## Technical Service Bulletin no. 21-284-B

New CCS version 1.8.21 and update of the variable frequency drives (hoisting, trolleying and slewing).

HUP32-27 and HUP40-30 delivered with a CCS version less than 1.13.4

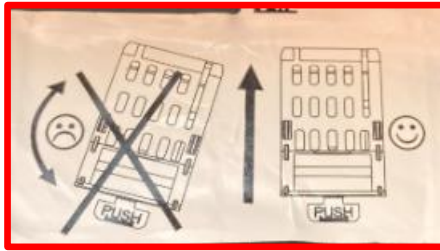
5. Remove the plug to install the Can Open card.

6. Install the Can open card.

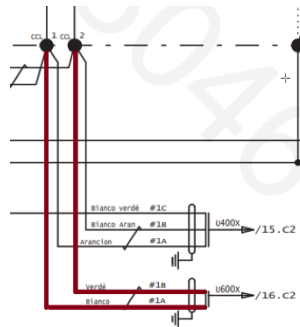
- Cable 84115199.

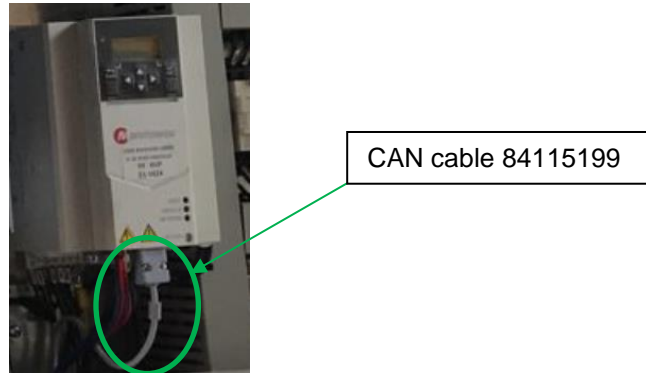
- 8) Connect the Peak Can on the USB port of the laptop or tablet and connect the other end of the Sub D9/ Sub D9 cord to the Peak Can.

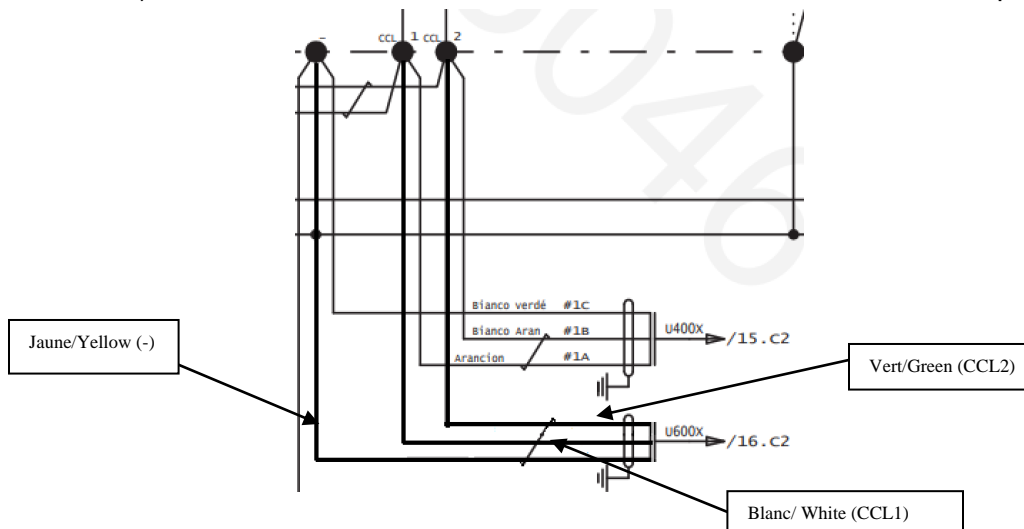
- 9) Reconnect the crane power supply and power up the crane.
- 10) Follow the Tutorial: **TUTO21-012-A** - Updating ACS380 with the Inverter Setting Tool.
- 11) Connect the Can cable, code 84115199, to the variable frequency drive.

- 12) Connect the Can cable, code 84115199, to the CCL terminal strip.
